TECHNICAL BULLETIN

[Issue No.] FA-A-0080

[Title] Changes in the appearance of the A1SD75P2-S3/A1SD75P3-S3positioning module **[Date of Issue]** May 2010

[Relevant Models] A1SD75P2-S3/A1SD75P3-S3

1. Main change

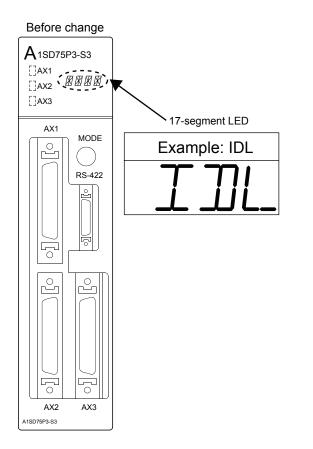
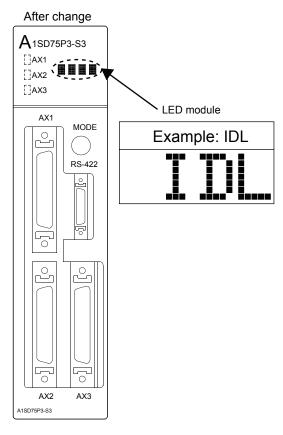
The LED display of the A1SD75P2-S3/A1SD75P3-S3 positioning module has been changed due to production discontinuation of some associated parts.

The 17-segment LED display has been changed to the LED module.

Note that the display method, general and performance specifications, and all other features of these models are unchanged.
